APPLICATION NO.	FILING DATE	FIRST NAMED INVENTOR	ATTORNEY DOCKET NO.	CONFIRMATION NO.
10/796,471	03/09/2004	Leilei Zhang	X-1574 US	2282
24309	7590	01/23/2007	EXAMINER	
XILINX, INC			DIAZ, JOSE R	
ATTN: LEGAL DEPARTMENT			ART UNIT	PAPER NUMBER
2100 LOGIC DR			2815	
SAN JOSE, CA 95124			MAIL DATE	DELIVERY MODE
			01/23/2007	PAPER

Advisory Action Before the Filing of an Appeal Brief	Application No.	Applicant(s)
	10/796,471	ZHANG, LEILEI
	Examiner	Art Unit José R. Diaz

FIG. 2B

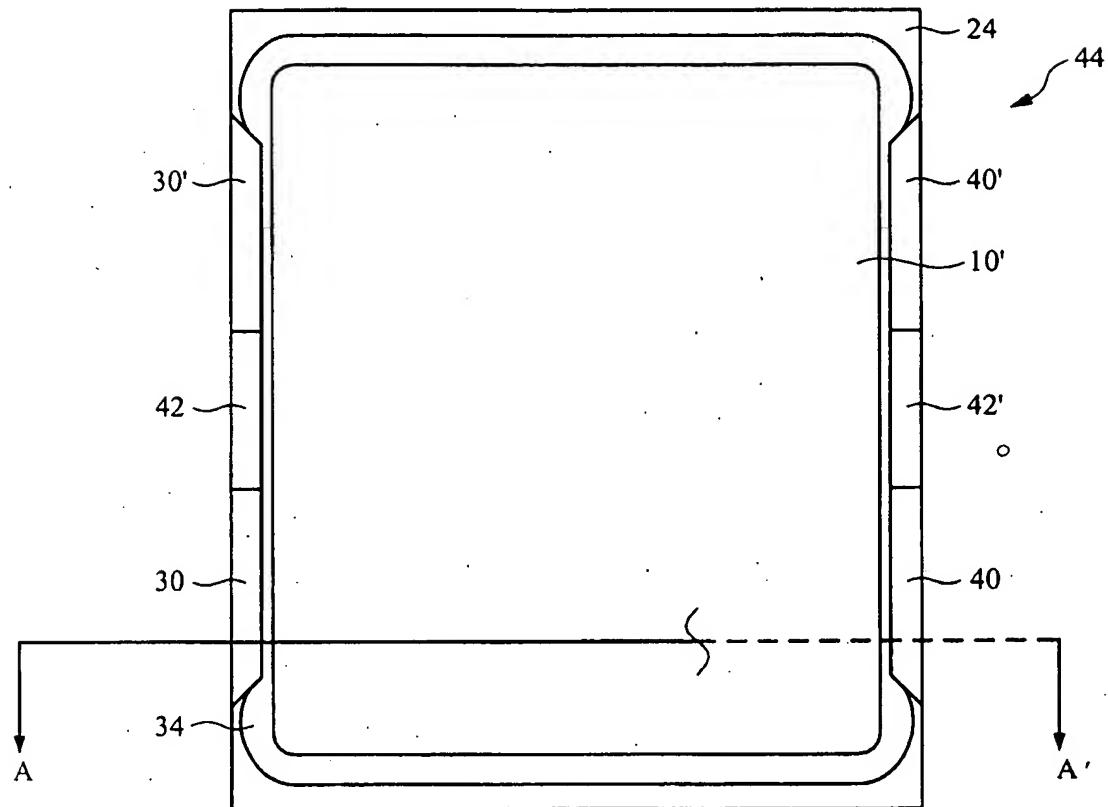
First, it is noted that the Statement of the Substance of the Informal Interview ("Statement"), as filed on December 18, 2006, is not accurate. In the Statement, applicant states that "[T]he Examiner suggested adding a section line to Fig. 2B and...indicating that the space around the chip capacitors in Fig. 2A is not filled with encapsulant." However, the examiner did not make those suggestions. In fact, Applicant was the one that suggested those amendments in response to the issues raised by the examiner. Therefore, the Statement should be corrected.

In addition, the proposed figures are objected since the device shown in figures 2A does not correspond to the device shown in figure 2B. For instance, figure 2A shows a sloped wall completely covered (from top to bottom) with molding compound (30), however figure 2B shows a partially covered sloped wall (34) (see the top portion of the sloped wall that is not covered with molding compound 30).

FIG. 2A

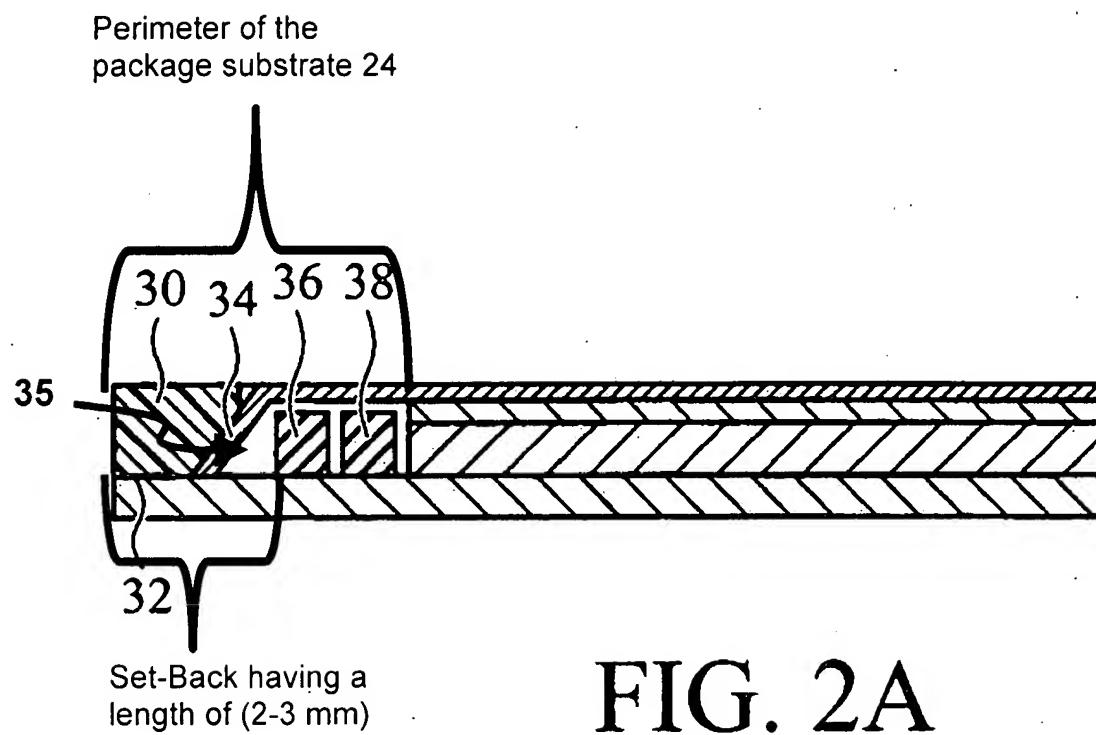
11. The request for reconsideration has been considered but does NOT place the application in condition for allowance because: _____
12. Note the attached Information Disclosure Statement(s). (PTO/SB/08) Paper No(s). 12/18/08
13. Other: Note the attached figure 2A.

After a carefully review of the original disclosure, it is considered that the proposed amendment add new matter to the specification. For instance, the original disclosure does not support the subject matter now added to paragraph 0030 since the original disclosure fails to suggest, explicitly or implicitly, that no molding compound is introduced in the space 35, as now proposed by applicant. To the contrary, the original disclosure suggests that molding compound is added in the argued space. For example, paragraph 0030 (of the original specification) discloses that the molding compound is formed on "about 2 mm to about 3 mm of the perimeter of the package substrate 24." Paragraph 0030 further discloses that "[T]he set-back from the edge of the package substrate 24 to the chip capacitors 36, 38 is typically about 2-3 mm." As it is illustrated in the attached figure 2A, a length of about 2-3 mm includes the portion 32 and the space 35. Thus, the molding compound is also present in the space 35.

Therefore, the figures remain objected by the examiner.
